**Hard Rock Quarry
Maytoms Lane, Booral**

**Review of
McLaren's Traffic and
Parking Assessment**

Ron Brown

July 2025

Figure 6-1: BAR and AUL Measurements for the Proposed Intersection of Maytoms Lane / Bucketts Way

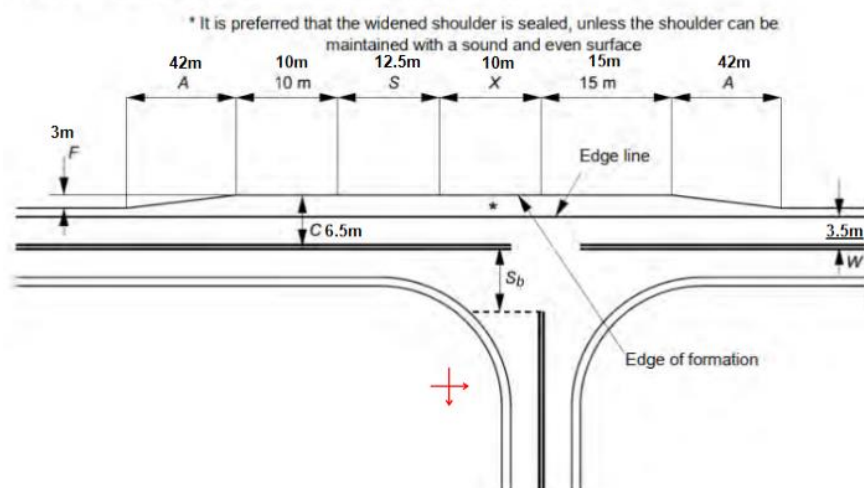
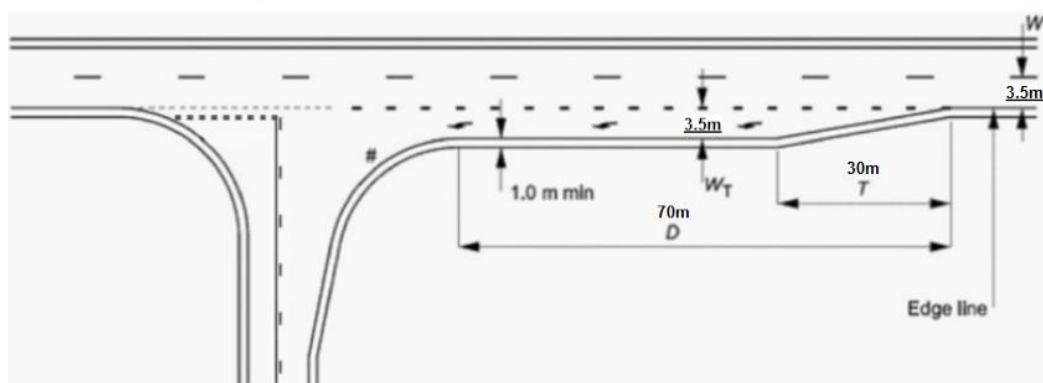
The BAR Right Turn measurements and intersection layout detailed in Figure 6-1 provides a widening that allows vehicles to overtake on the left vehicles turning right into Maytoms Lane of turning right out of Maytoms Lane. The distance provided for a southbound vehicle to pass a show moving Truck turning right out of Maysoms Lane is 15m.

It is considered that the widening provided on the eastern side of The Bucketts Way is inadequate and will need to be extended by at least 100m in order to allow southbound traffic to overtake a truck leaving Maytoms Lane as he accelerates up to 100kph.
